Access Compliance Report

Public Rights-of-Way

(Curb Ramps)

Intersection ID: 22554	Main Street: OXWYNN_LN	Cross Street: SUMMERTREE_LN	Location:	W
ADA ID: 8B6EBFD92F0B	Ramp Type: PerpDiag	Initial Pass/Fail: Fail	Overall Compliance: No	Severity Score: 25
Codes/Mitigation Info/Possible Solution		Field Measurements/Component Compliance

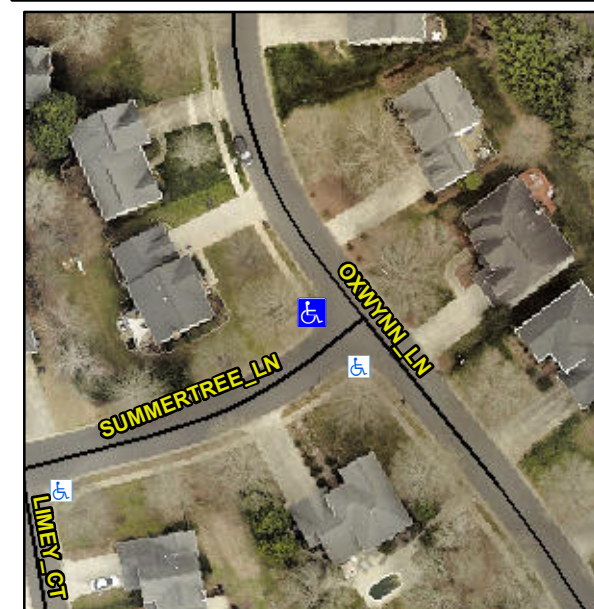
R304.2.2, R304.5.3

Compliance	Description	Data	Compliance	Description	Data
N/A	Ramp Length (in)	76.5	No	Ramp Slope (%)	9.1
Yes	Ramp Width (in)	48.0	No	Ramp XSlope (%)	5.4
N/A	Flare Type LT	N/A	N/A	Flare Type RT	N/A
N/A	Flare Slope LT (%)	N/A	N/A	Flare Slope RT (%)	N/A
N/A	Flare Traversable LT?	N/A	N/A	Flare Traversable RT?	N/A
N/A	Landing Length (in)	N/A	N/A	DWS Provided?	N/A
N/A	Landing Width (in)	N/A	N/A	DWS Contrast?	N/A
N/A	Landing Slope (%)	N/A	N/A	DWS Length (in)	N/A
N/A	Landing X Slope (%)	N/A	N/A	DWS Full Width?	N/A
N/A	Landing Curb? (Y/N)	N/A	N/A	DWS Offset (in)	N/A
N/A	Shared Landing?	N/A			
N/A	Gutter Ponding?	N/A	N/A	Gutter Slope (%)	N/A
N/A	Gutter Lip Ht (in)	N/A	N/A	Gutter X Slope (%)	N/A
N/A	Painted X Walk1?	No	N/A	Painted X Walk2?	No
	X Walk 1 Direction	To S		X Walk 2 Direction	To E
N/A	X Walk 1 Width (in)	N/A	N/A	X Walk 2 Width (in)	N/A
	X Walk 1 Slope (%)	5.2		X Walk 2 Slope (%)	2.2
	X Walk 1 X Slope (%)	0.1		X Walk 2 X Slope (%)	0.1

Remove & Replace Curb Ramp With Two New Directional Ramps or Equivalent.
